Management of Change: BASF process column K 2750 (DEXPI C02, unseen)

DRAFT - NOT APPROVED. Prepared 2026-11-02 15:28 +03 by PlantAgent from the working model. Nothing in this file is an approval.

Decision requested	**Simulator screening passed; proceed to data and vendor verification (not ready for approval): 1 change to reach 120 % of today's throughput - (1) Replace column with 600 mm ID rated shell (vendor to confirm).**
Target	120 % of today's throughput
Result (DWSIM, re-solved for this file)	At 120 %, existing plant: 1 limit over 100 % (highest K 2750 distillation Fair flood fraction vs limit 110 %); with the changes: all modelled process limits within 100 % (highest K 2750 distillation Fair flood fraction vs limit 76 %). Simulated maximum throughput: 113.1 % → 145.1 % of today.
Cost class (agent estimate, unpriced)	(1) not stated
Needs approval	(1) Replace column with 600 mm ID rated shell (vendor to confirm): cost class not stated (agent estimate), replacement rating (vendor confirmation open); Pre-startup safety review: 6 items (section 6.2).
Status	DRAFT for engineering review; to be checked by a licensed engineer. Sign-off in section 7.

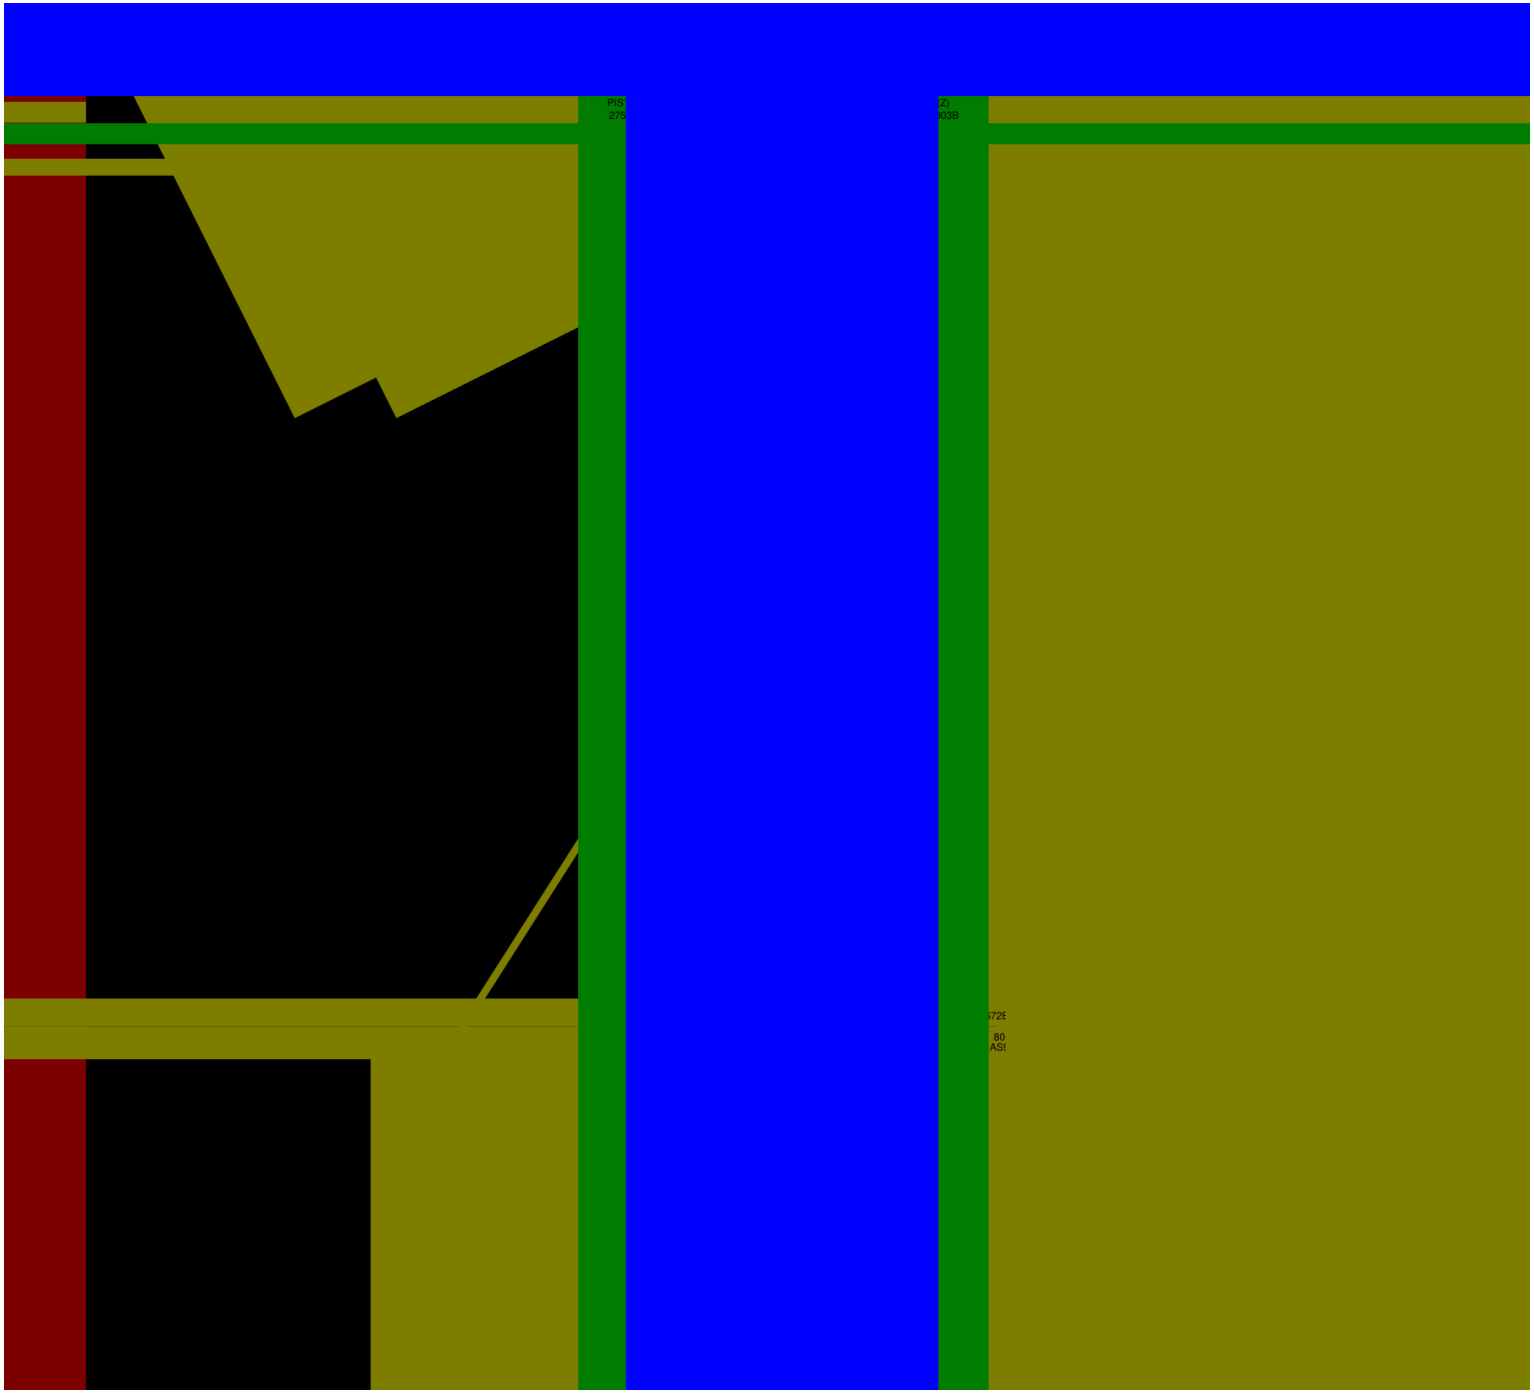
4.1 Replace column with 600 mm ID rated shell (vendor to confirm)

Cloud 1 on the Rev B drawing. Cost class (agent estimate, unpriced): not stated.

- Replaces K 2750 distillation: diameter m 0.6 (DWSIM Fair flood requires 0.638 m at 1.32× scaled 3.96 mol/s; 600 mm uniform (next standard matching KX 2750 600 mm section) gives 0.604 vs 0.80 =75.5 % at envelope (K2750_1p32_600_verify) and 0.549 =68.6 % at 1.2× (K2750_1p2_600 family); 525 mm gives 0.789 =98.6 % no margin (K2750_1p32_525). Height 14000 mm, 6 bar/150 °C, 1.4571, 15 stages same.; vendor to confirm)
- On the drawing: K 2750 REPLACED: diameter m 0.6 (vendor to confirm).

Why. Existing 500 mm ID cannot pass the +10 % operating envelope even with correct split: 0.869 vs 0.80 =108.6 % at 1.32× scaled (K2750_1p32_scaled_500) and 1.008 =126 % fixed (K2750_1p32_fixed_500). All documented P/T checks pass (<61 % at 1.32×) so flooding and purity are the only documented limits. New 600 mm ID provides required capacity with margin; vendor to confirm tray/valve design, downcomers, nozzles for line 2750.001.6 and *at N3*/*C2* valve.

- K 2750: agent-proposed sizing basis (not independently validated): DWSIM Fair flood requires 0.638 m at 1.32× scaled 3.96 mol/s; 600 mm uniform (next standard matching KX 2750 600 mm section) gives 0.604 vs 0.80 =75.5 % at envelope (K2750_1p32_600_verify) and 0.549 =68.6 % at 1.2× (K2750_1p2_600 family); 525 mm gives 0.789 =98.6 % no margin (K2750_1p32_525). Height 14000 mm, 6 bar/150 °C, 1.4571, 15 stages same.; vendor confirmation open

5.1 P&ID Rev A - existing (as received)

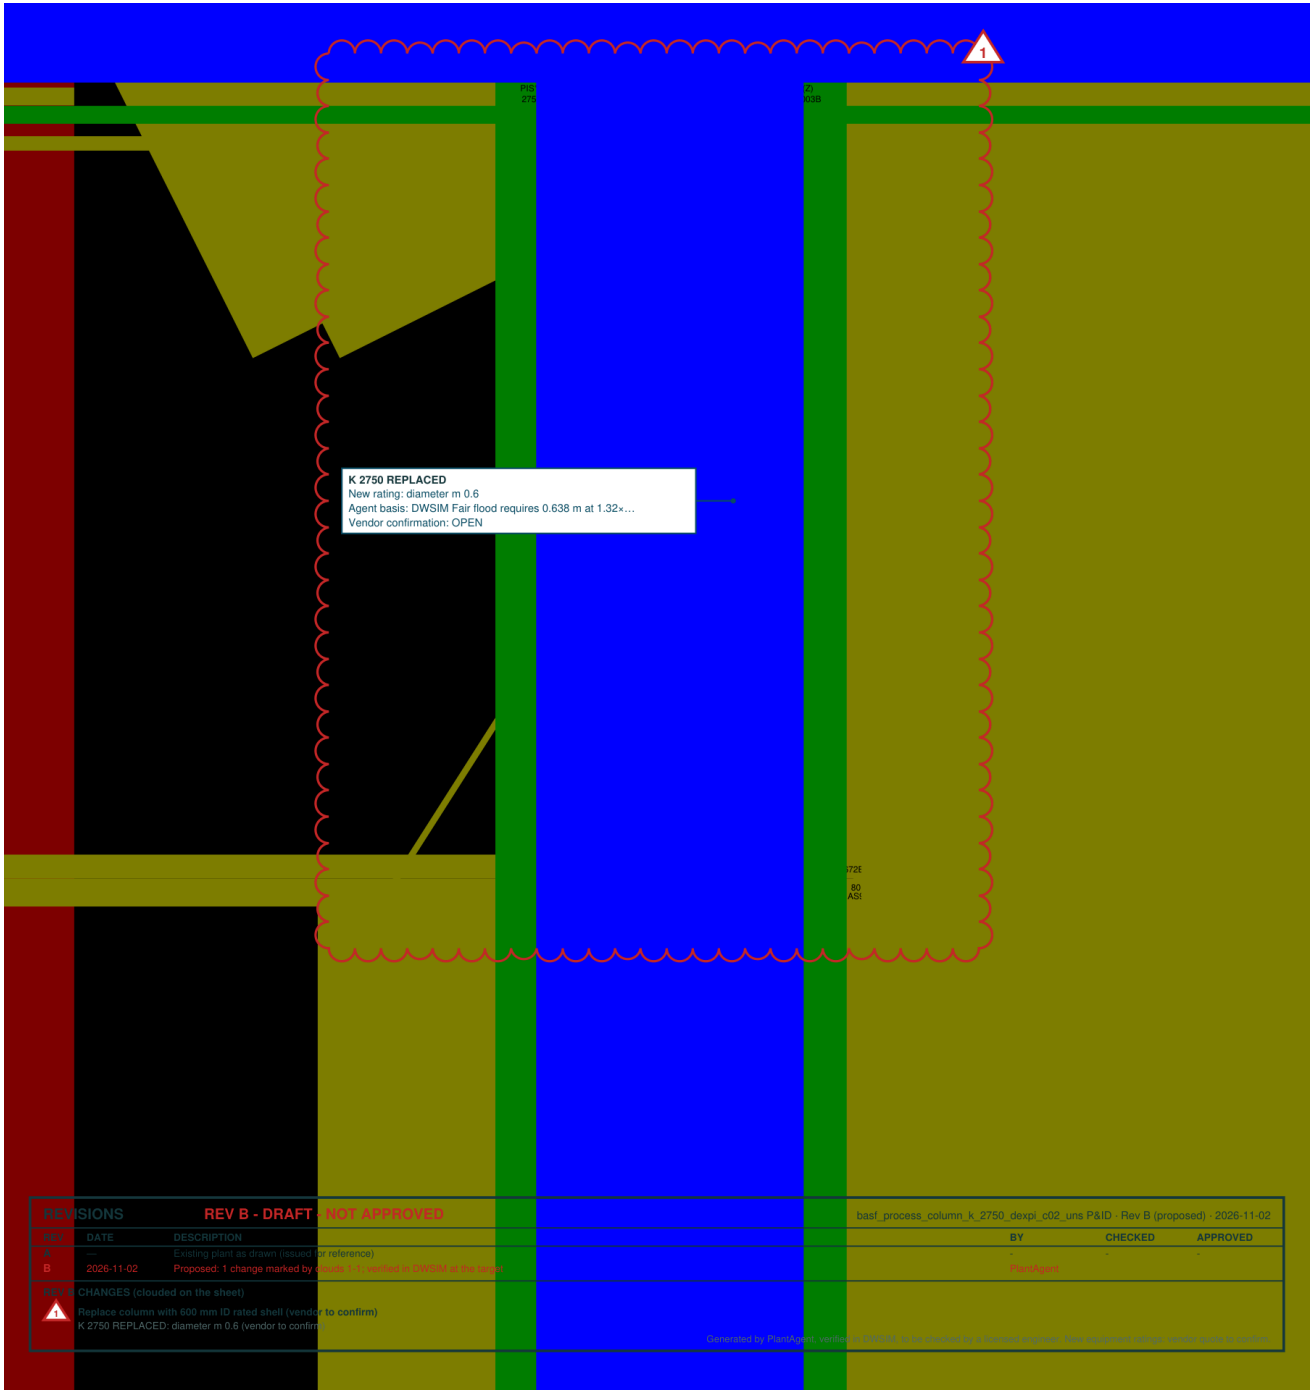
- **Finding:** K 2750 all side: no relief on this P&ID. no relief device reachable (lines leave the drawing: check the connecting P&ID).
